Response to the Reviewer's comments - review 2

Investigation into Instantaneous Centre of Rotation for Enhanced Design of Floating Offshore Wind Turbines.

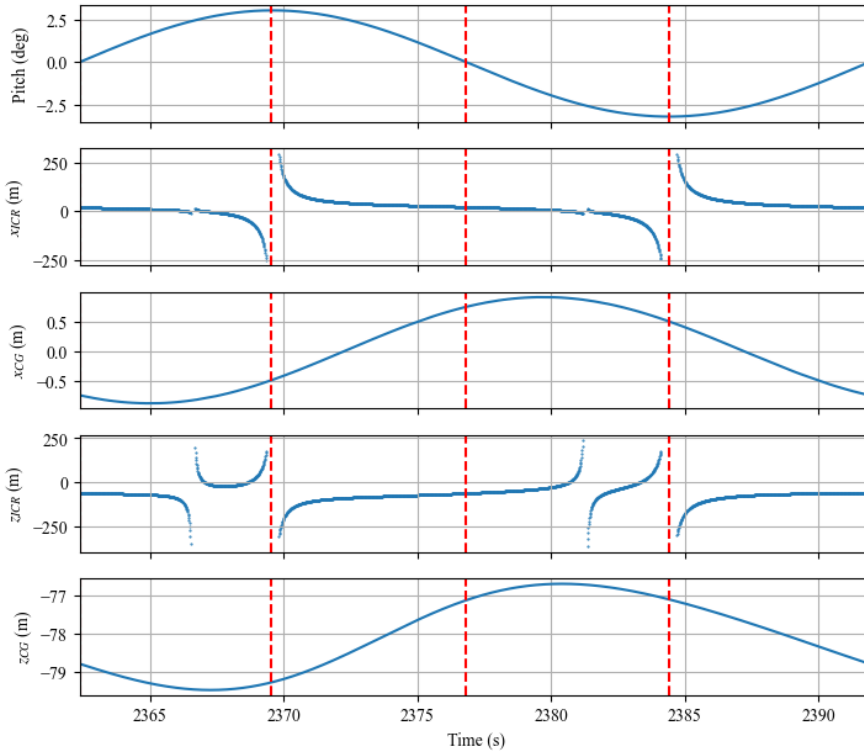
Comment 17 "Line 202: It is not very easy to interpret the results, if I am only to look at Fig 2. Are you able to make a plot of the trajectory of the ICR, for one cycle of one of the regular waves, to illustrate a bit better how the ICR moves? You could for example plot also the floater CG trajectory, in the same figure. Very important to show the coordinate-system axes, too".

Response 17 The plot of the ICR trajectory during one pitch period in regular waves is provided in Figure 3 and discussed in Section 2.1. The coordinate system is illustrated in Figure 7 as defined

in Section 2.4. The plot of the centre of gravity trajectory is shown in the figure below. We decided not to include this plot in this paper as the position of the centre of gravity only partly impacts the ICR, and does not fully explain its behaviour therefore would not be very informative in the context of the results discussed but could lead to confusion.

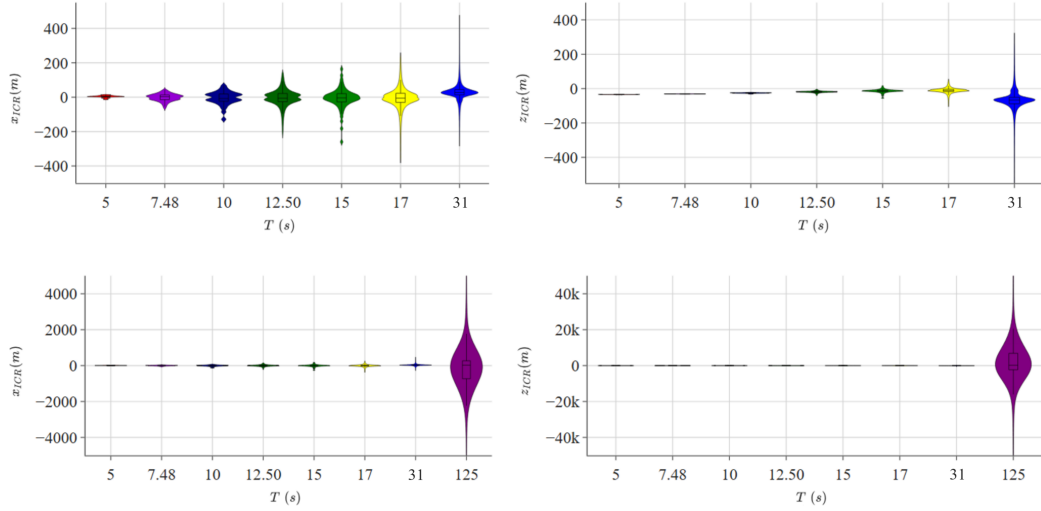
Comment 18 "Line 204: The longest period considered is 17.0 s. It is hard to believe that these

waves will excite surge ($T_n = 125$ s) very significantly. Even the heave natural period (31 s) is a bit far from that. What is the pitch natural period? If it is not much longer than 17 s, could it be that the increased surge motion is actually caused by coupling with pitch?”

Response 18 Thank you for your careful assessment of the discussion. We did not present the results for periods higher than 17 s as such long waves are rare in real sea states, based on the metocean data. We did analyse the cases of 31 s (pitch natural period) and 125 s (surge natural period), and these resulted in very wide ICR distributions, as presented in the figure included below.

The mechanism leading to the increase of ICR distribution width is the increase of the system response with the exciting frequency decreasing from very low towards the region of the natural frequencies of the system. As seen in the plots below, the surge, heave, and pitch RAOs increase between the periods of 5 s and 17 s, therefore any given wave amplitude will exert higher motions at 5 s than at 17 s, in all rigid body modes.
